RS-16-193

LaSalle County Station, Units 1 and 2
Renewed Facility Operating License Nos. NPF-11 and NPF-18
NRC Docket Nos. 50-373 and 50-374

Subject: License Amendment Request to Revise Suppression Pool Swell Design Analysis

Comparison of Velocity Profiles

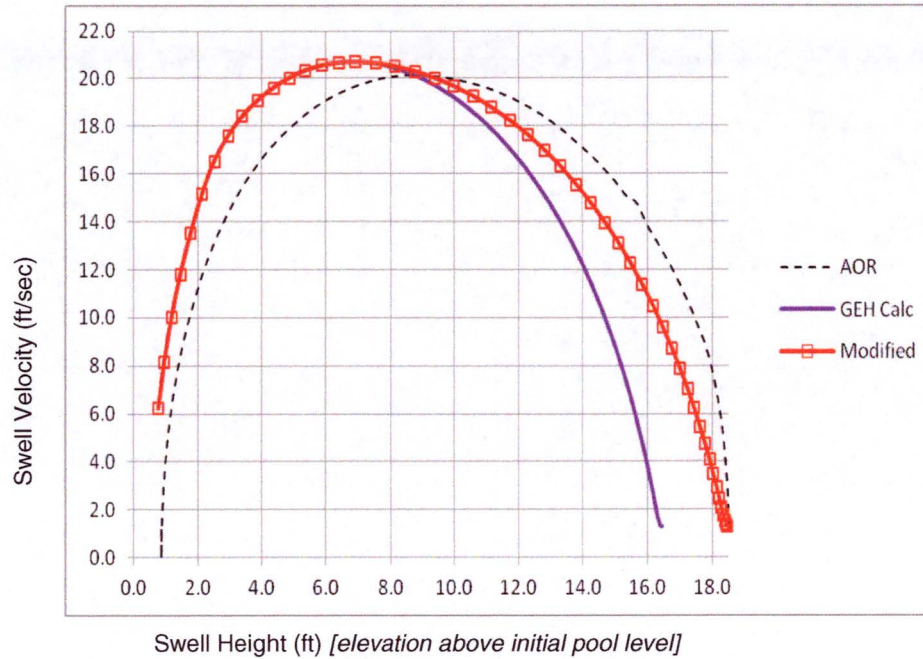
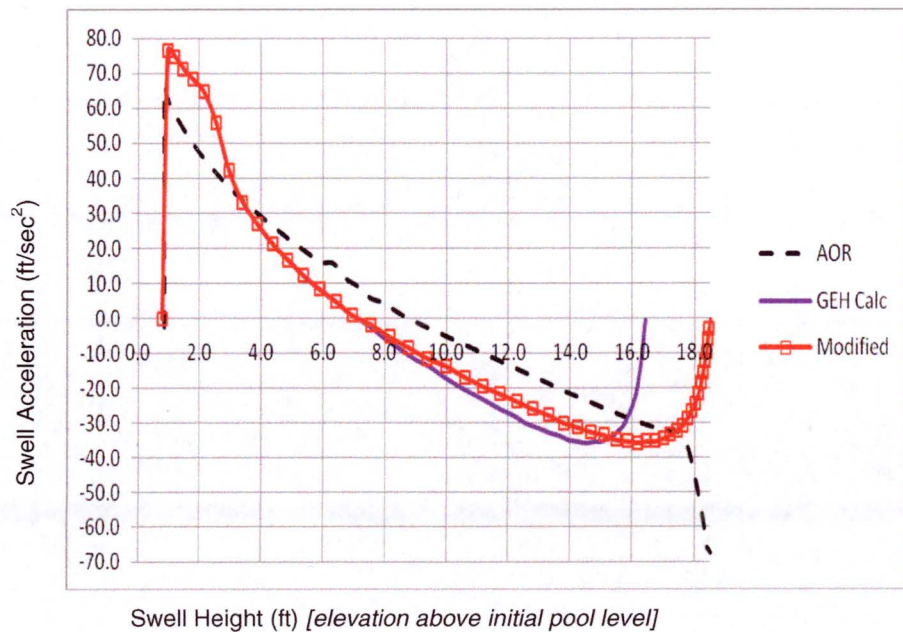
<p>As previously mentioned, Exelon has elected to utilize Case 3 of Reference 5; however, to ensure compliance with the NRC criteria, Exelon has modified the suppression pool swell velocity and acceleration profiles to ensure the suppression pool swell height is 18.5 ft. The modification to the suppression pool swell velocity profile and the suppression pool swell acceleration profile is shown in the following figures.</p>	Scenario	Vent Flow	Peak Swell Velocity	Peak Swell Height	AOR	100% air	20.14 ft/sec	18.5 ft	Case 1	100% air	26.91 ft/sec	20.1 ft	Case 3	Air/Steam Mix	20.68 ft/sec	16.44 ft
Scenario	Vent Flow	Peak Swell Velocity	Peak Swell Height															
AOR	100% air	20.14 ft/sec	18.5 ft															
Case 1	100% air	26.91 ft/sec	20.1 ft															
Case 3	Air/Steam Mix	20.68 ft/sec	16.44 ft
